Project 1706 - Proposed New Residential Construction Project (DPD #3019360)

Presentation Package

SEATTLE DESIGN REVIEW

08.03.2015 | Early Design Guidance Meeting 1
04.04.2016 | Design Review Recommendation Meeting 1

AERIAL FROM EDG MEETING #1

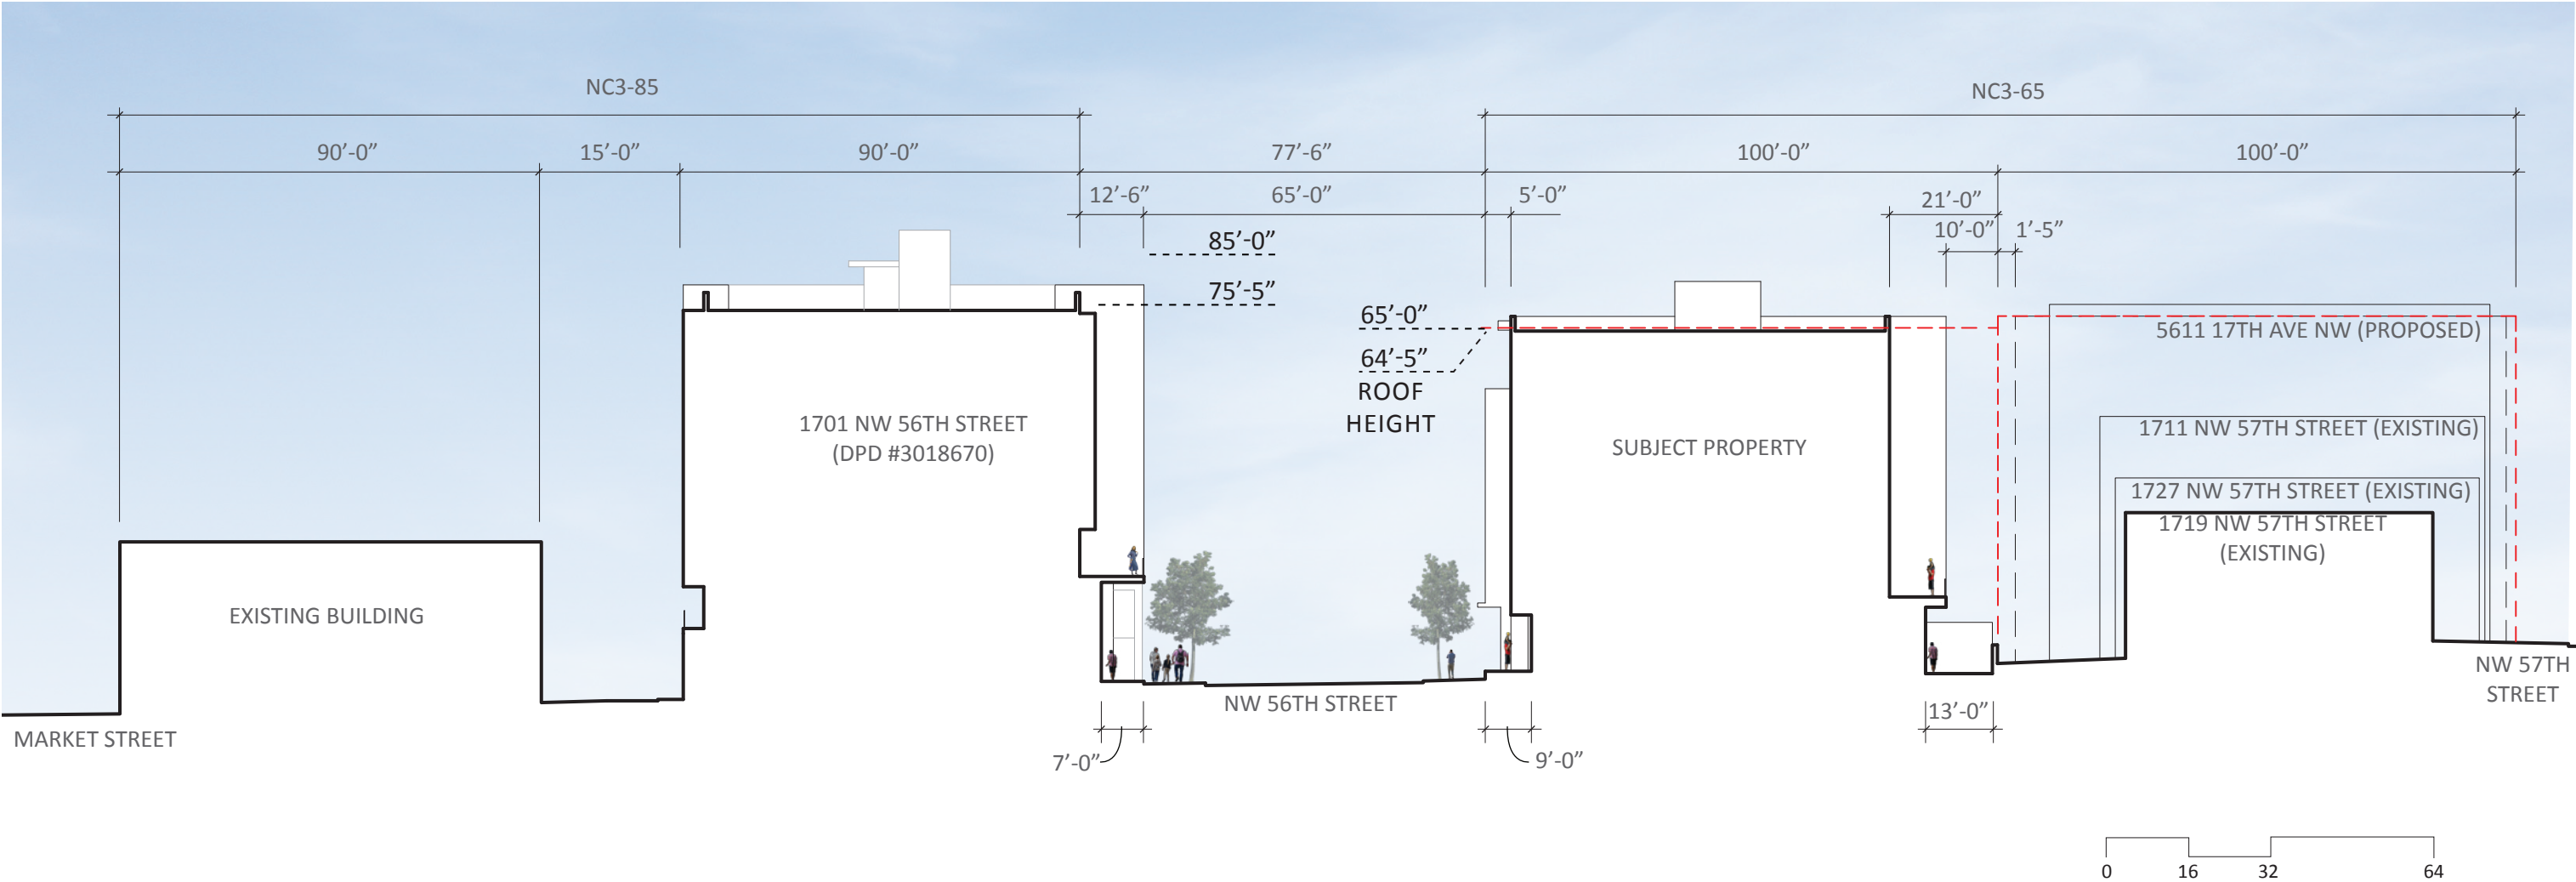
“The eastern massing should respond to the transition from a higher zone to the south and lower zone to the north.”

“The applicant should provide window studies for the properties to the west and north of the proposal.”

Building to the extent of the zoning envelope creates a gradual transition in scale from north to south and compliments the property at 1701 NW 56th Street. Variation in setbacks at the street level help reduce bulk and scale and strengthen pedestrian connectivity.

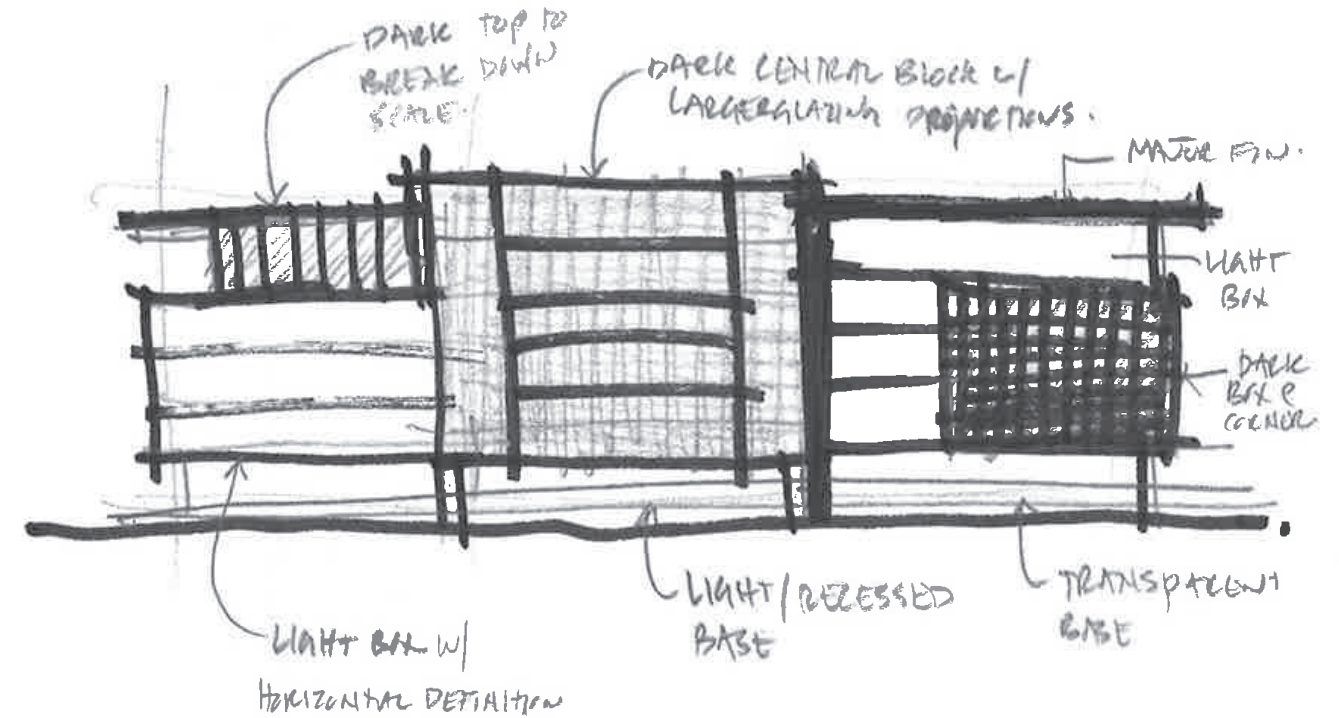
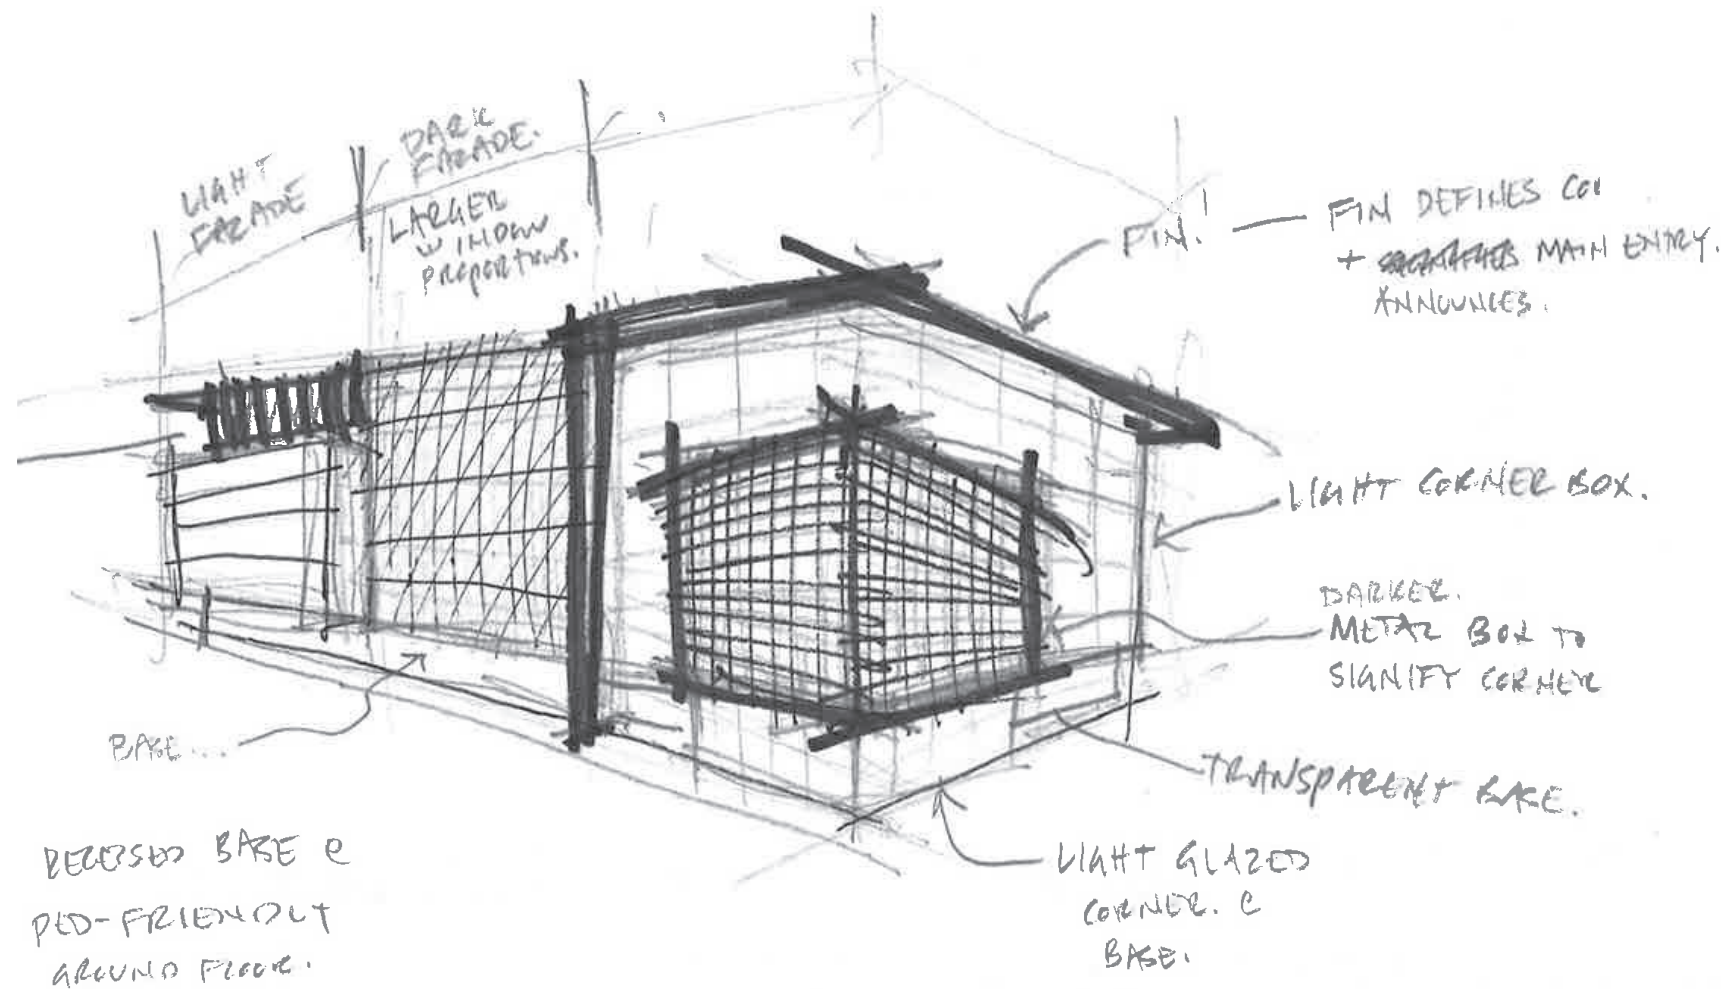
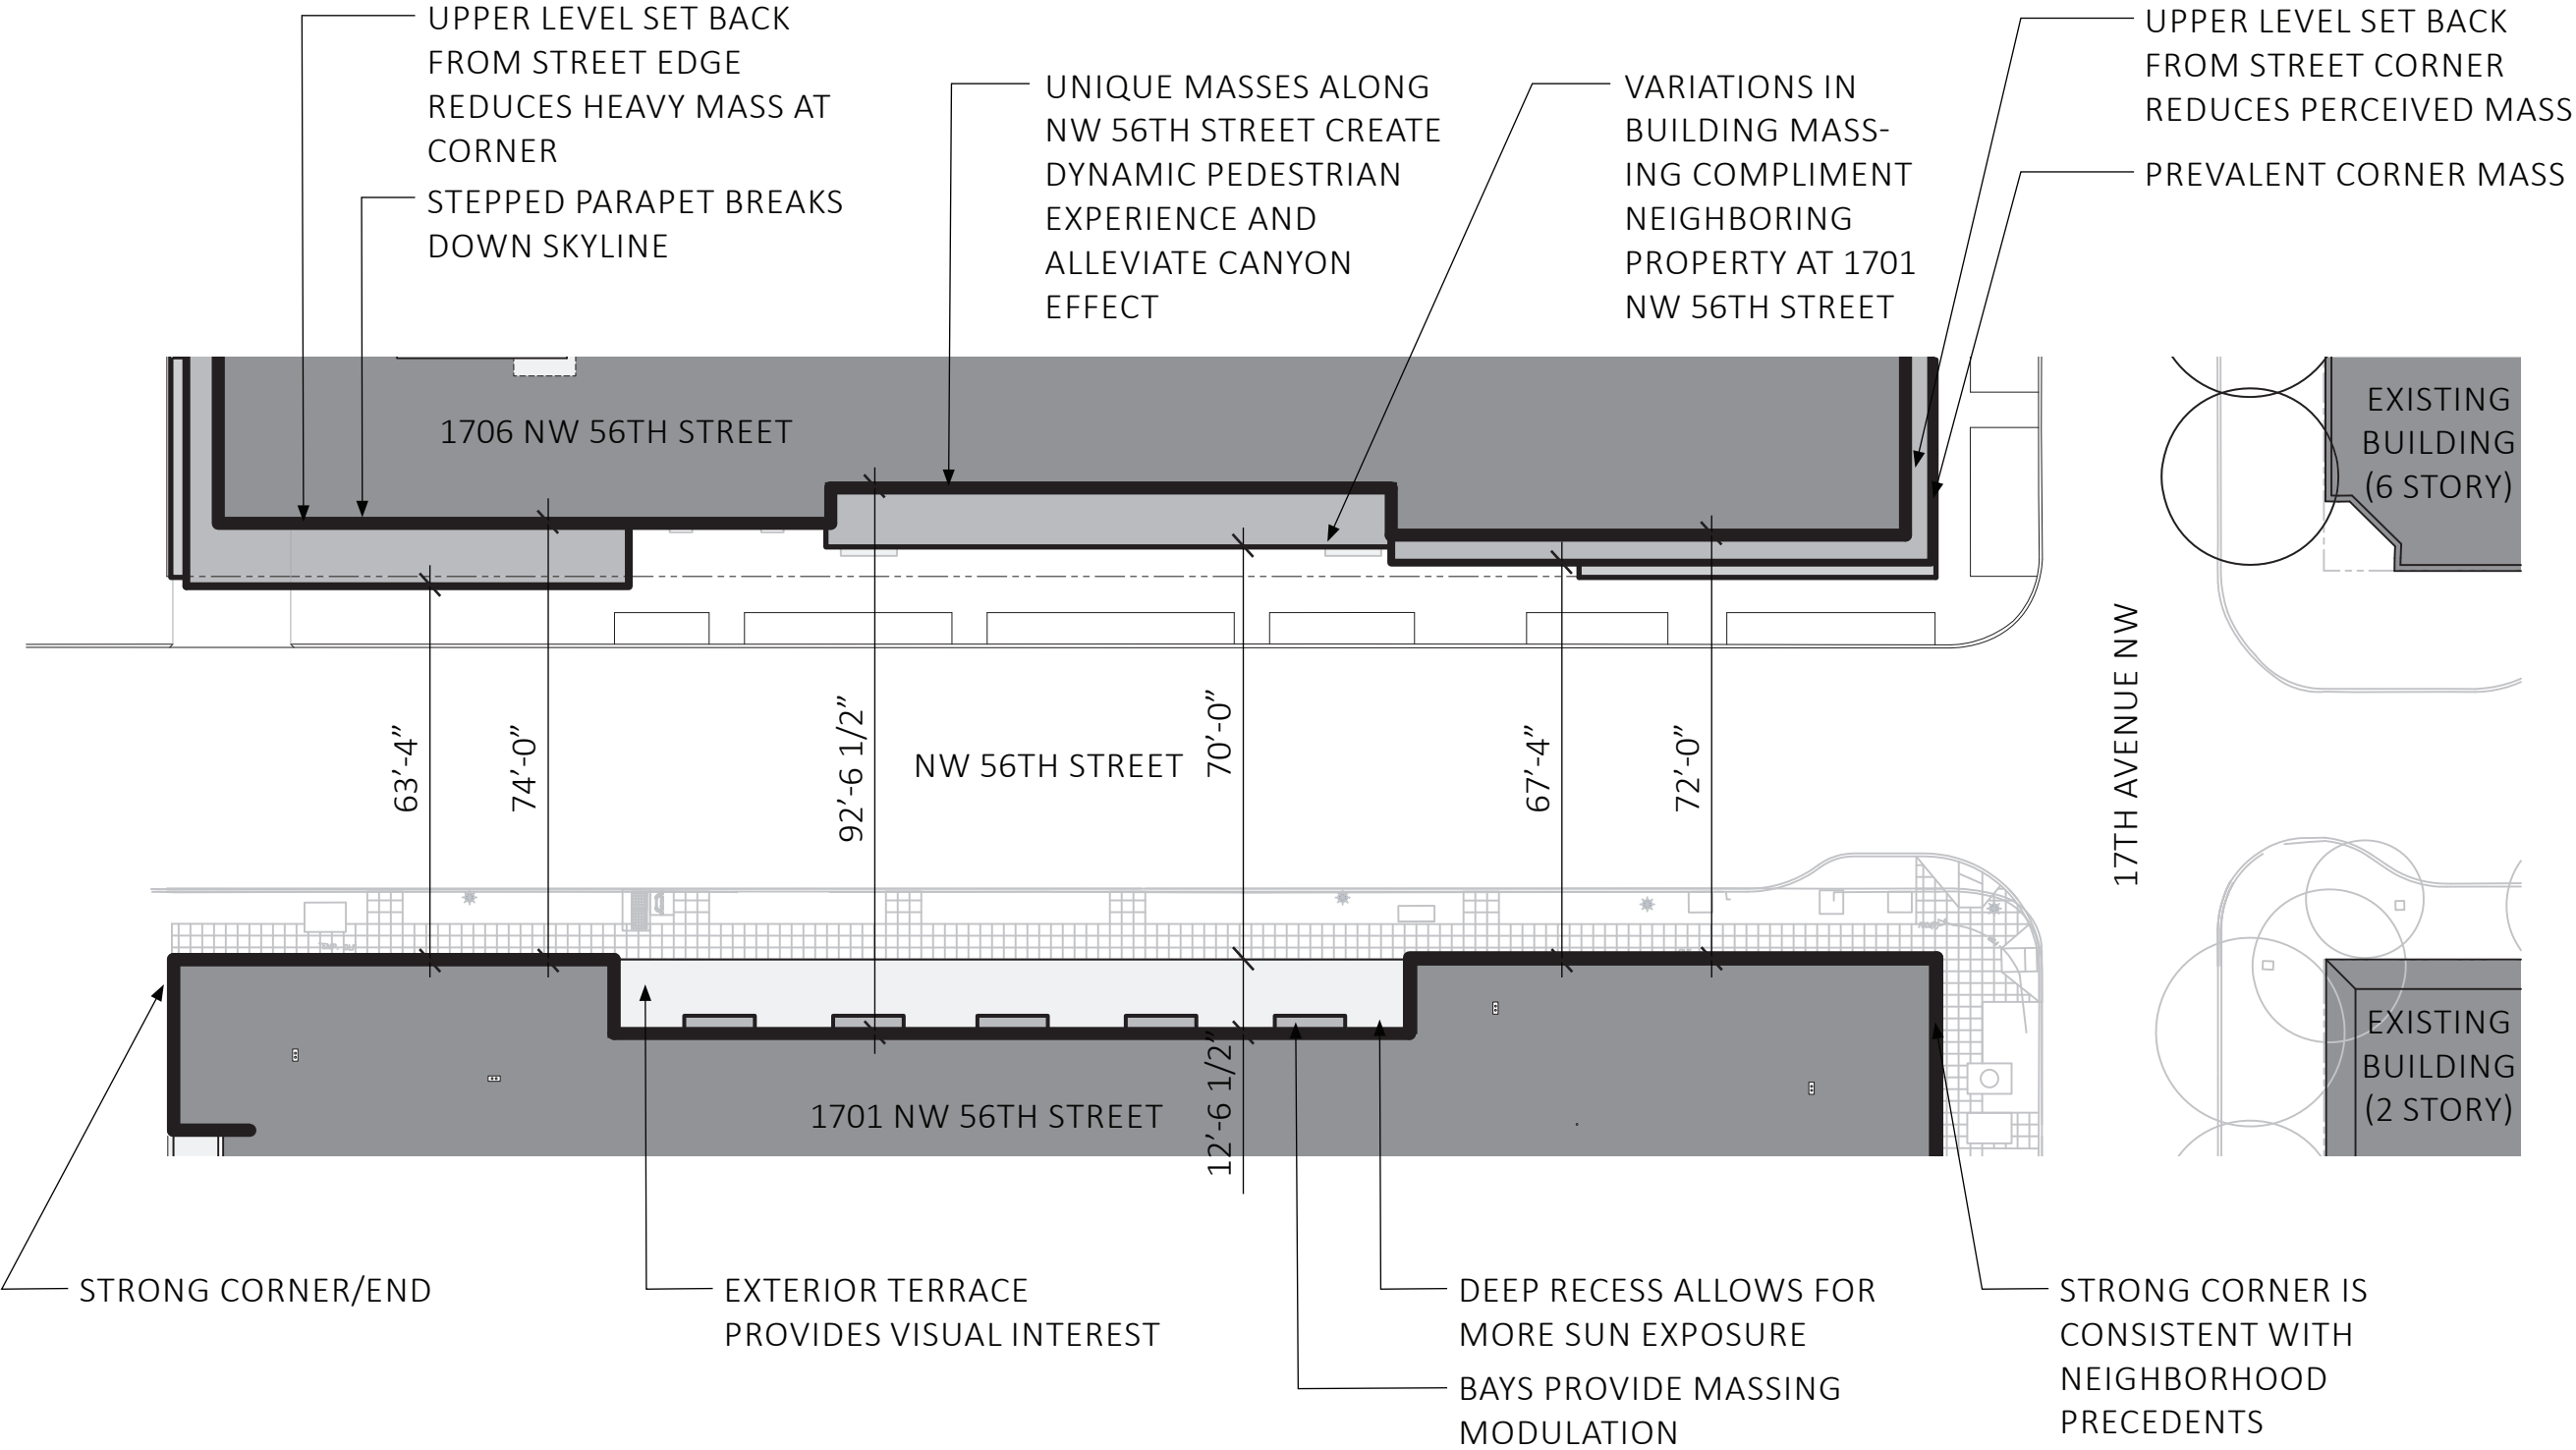
“The board expressed concern with the large scale and perceived mass of the proposal considering the 300 ft. length of frontage along NW 56th St. and expressed concern that it will read as one large building. The Board directed the applicant to look at ways to further break down the scale and mass of the building through additional emphasis on the vertical articulations and exploration of larger volumes with smaller, deeper recesses to better integrate and emulate the smaller scale of established development in the area.”

“The board expressed concern with the 300 ft. long parapet on both the north and south edges. For the next meeting, the applicant should incorporate ways to break down the scale and length of the north and south parapets.”

In an effort to break down the scale, the design team divided the massing into 4 main parts.
